APPLICATION NUMBER: 24/0610

PROPOSAL: CONDITIONS OF 21/0184 RESERVED MATTERS APPLICATION
OUTLINE PERMISSION 16/0864 FOR RESIDENTIAL DEVELOPMENT
OF UP TO 1100 DWELLINGS AND ASSOCIATED INFRASTRUCTURE

SITE: Llanwern Village Development Site, Phase 1 Cot Hill, Llanwern

APPLICATION TYPE: Conditions

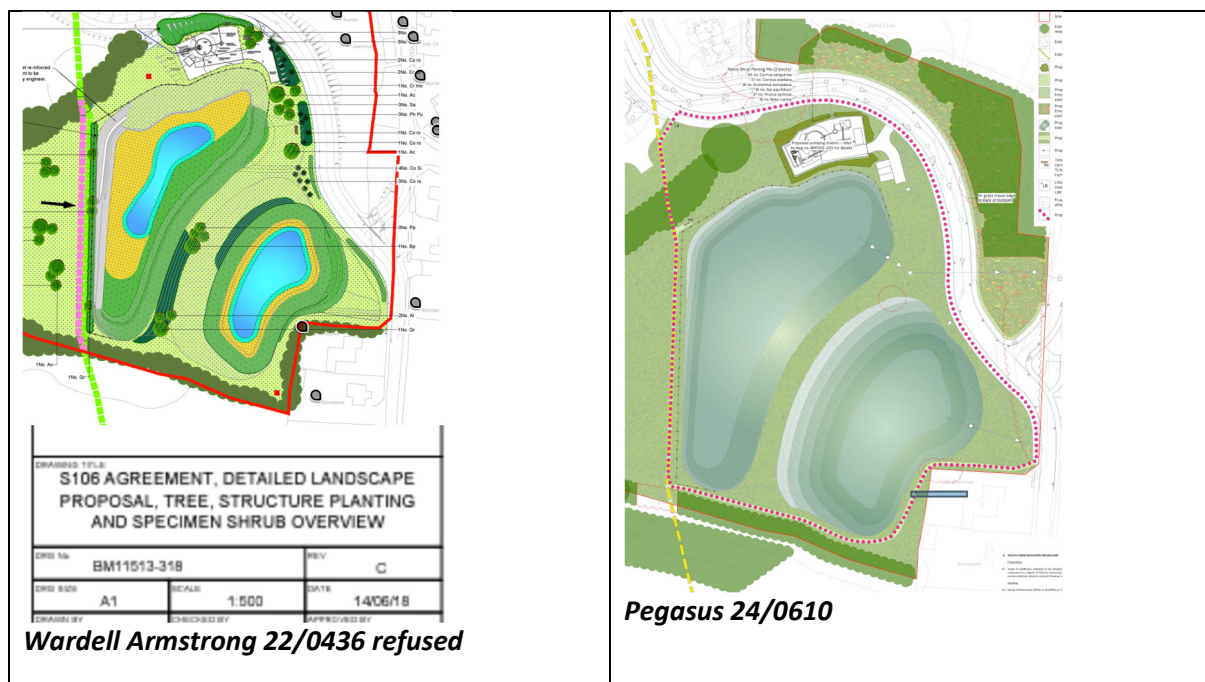
None of the submitted plans state levels. It is recommended these are shown on the landscape plan (P23-0521_EN_13_Rev C) by Pegasus.

The covering letter by Redrow states 'landscaping scheme to screen the pumping station which consists of a native shrub planting mix which will grow to between 40cm and 80cm to screen the pumping station'. This is clearly incorrect and confirmation of the height the vegetation will be maintained to is required from the applicant.

Blocks of planting are shown on the 24/0610 plan by Pegasus (below right) but not detailed, I assume this has been approved previously or is detail still required?

The refused 22/0436 for the same conditions shows a planting plan by Wardell Armstrong (below left). This provides screening for the car parking area, better integrates the attenuation basins with planting, provides planting along the length of the public right of way. The proposal by Pegasus provides much less green infrastructure.

I am not clear what has been previously approved but advise that the discrepancy is resolved to ensure public views are onto a high-quality designed space.

Condition 4: Circular Pathway

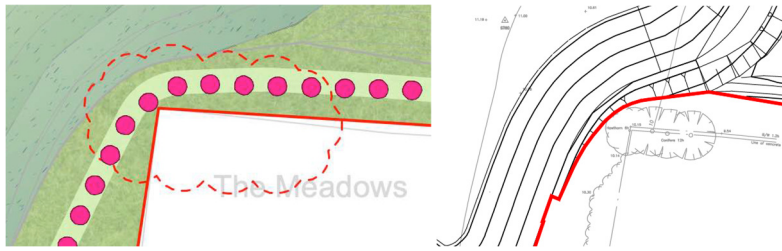
A close mown path is proposed to provide a circular pathway and is very tight to the south. If mowing is not sufficient, the path will become unusable.
